## Green Star – Office Interiors v1.1

### Indoor Environment Quality IEQ-6 Electric Lighting Levels

## Green Star Credit Interpretation Request (CIR) Form

To	<b>GBCA</b>	CA No	<b>VD-01</b>
Attention	<b>Joe Karten</b>	Date	<b>16 February 2009</b>
From	<b>Amara Clarke</b>	Facsimile	
Project	<b>GBCA HEAD OFFICE FITOUT</b>	Project No	<b>SYD0703900</b>
Contract		No. of pages	<b>2</b>
Copies

# Meeting Rm Scene ①

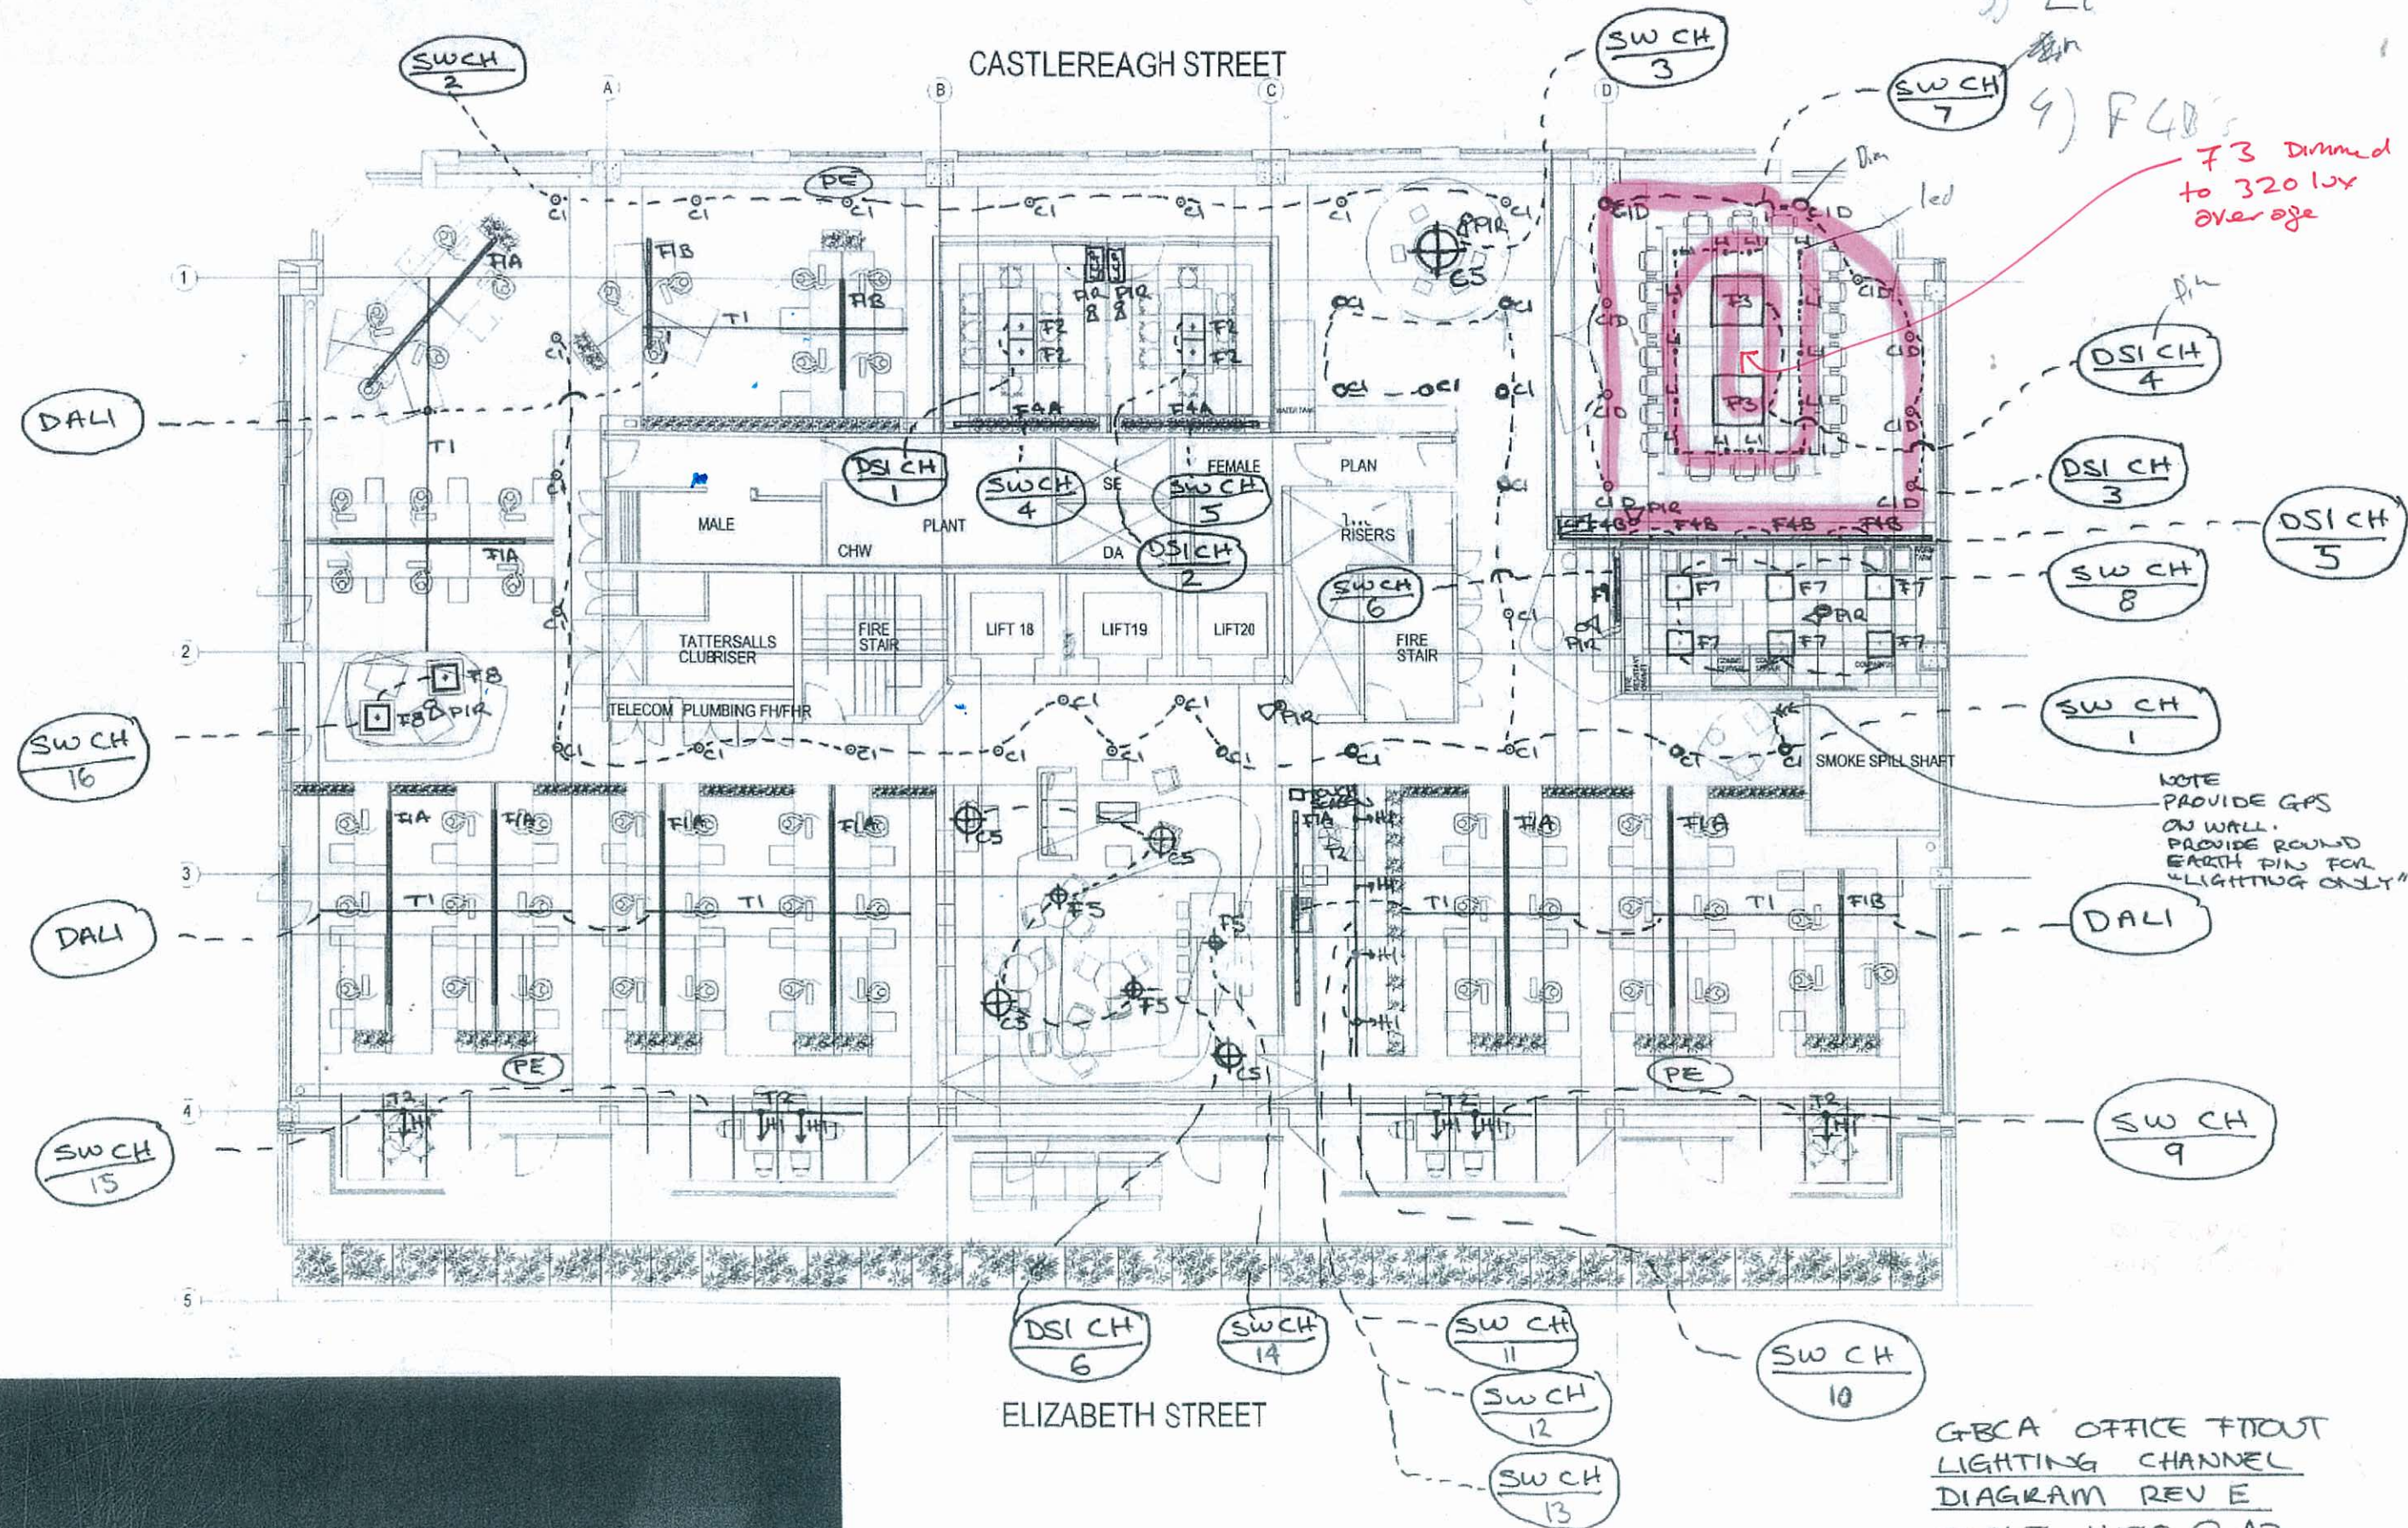
Scene 1: Standard Meeting Mode – all lights on, with Type F3 dimmed to 320lux average (refer to Boardroom Scene 1 markup). This will be the default setting and activated by the PIR.

## IEQ-6 ELECTRIC LIGHTING LEVELS - CREDIT POINT 1

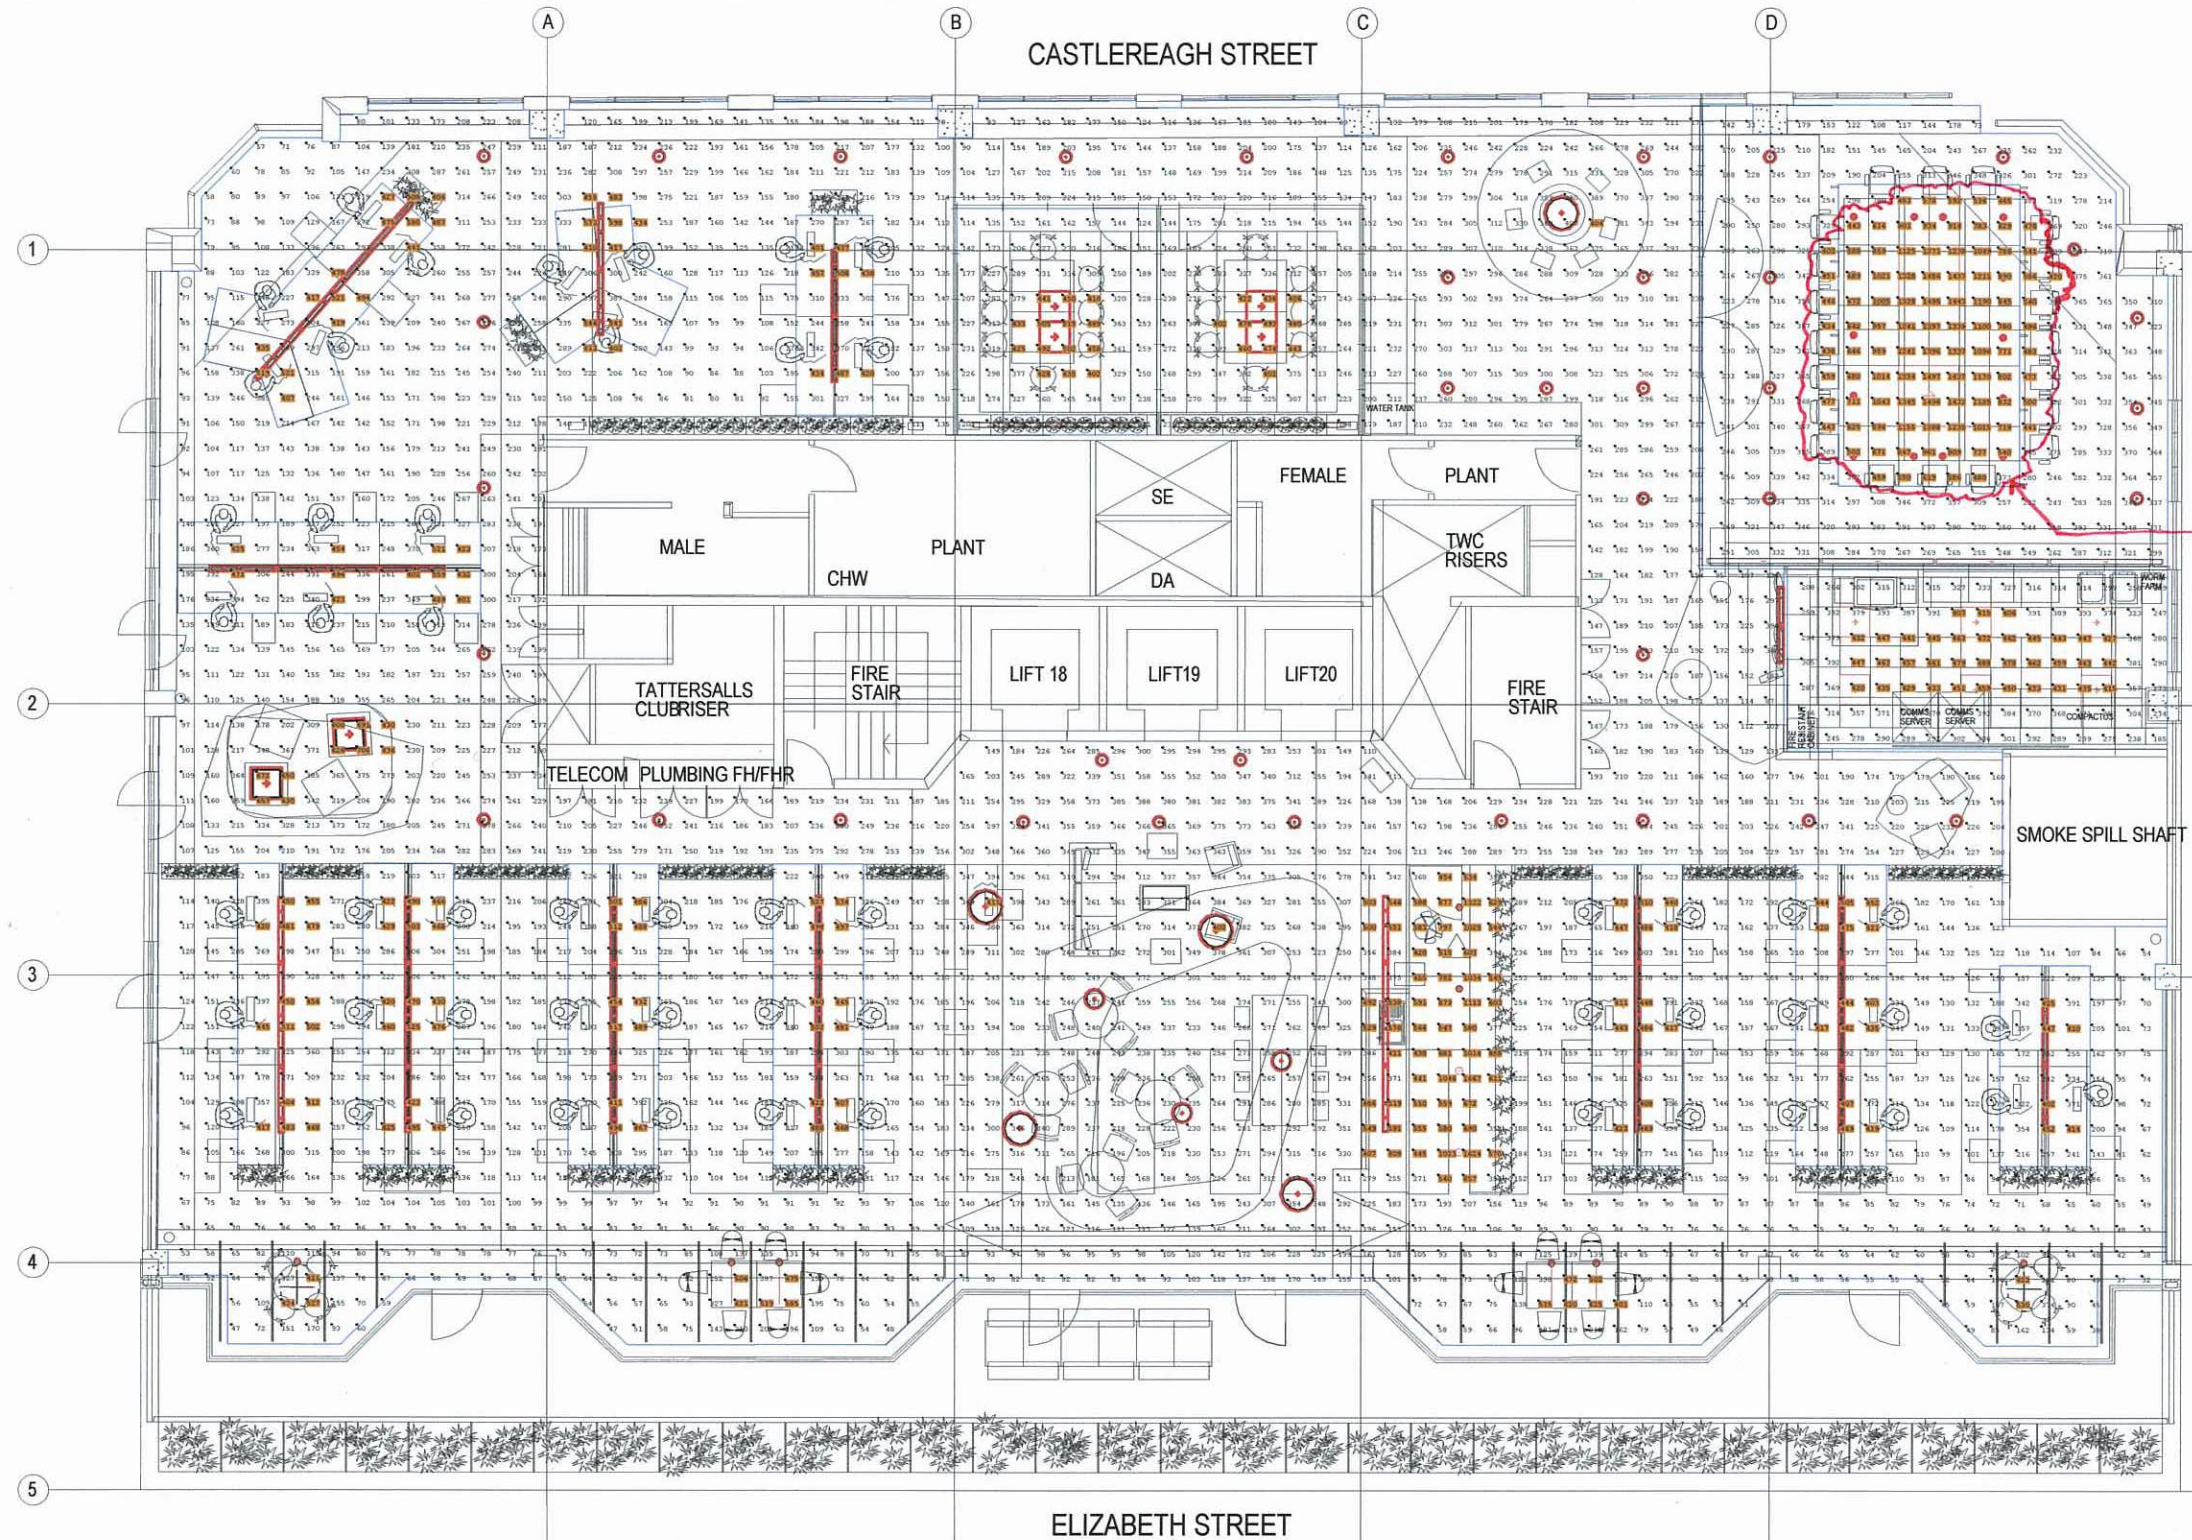
THE FOLLOWING AREA ABOVE 400 LUX HAS BEEN EXCLUDED FROM THE TOTAL FOR THE FOLLOWING REASON:

Note 1: Video Conferencing requirements of > 800 lux. Lighting control system will limit levels to 320 lux average when video conferencing not in use. PIR detection sensor to be installed so that the boardroom lighting is only switched on when occupied.

**CIR Ruling:** The CIR to exempt the "video-conferencing mode" settings for a particular room from meeting the criteria of this credit is **granted conditionally** on the project's ability to demonstrate that the default setting of the room is less than 400 Lux, and that the lighting controls will reset the room's illumination levels back to the default level when the video-conferencing equipment is not in operation.
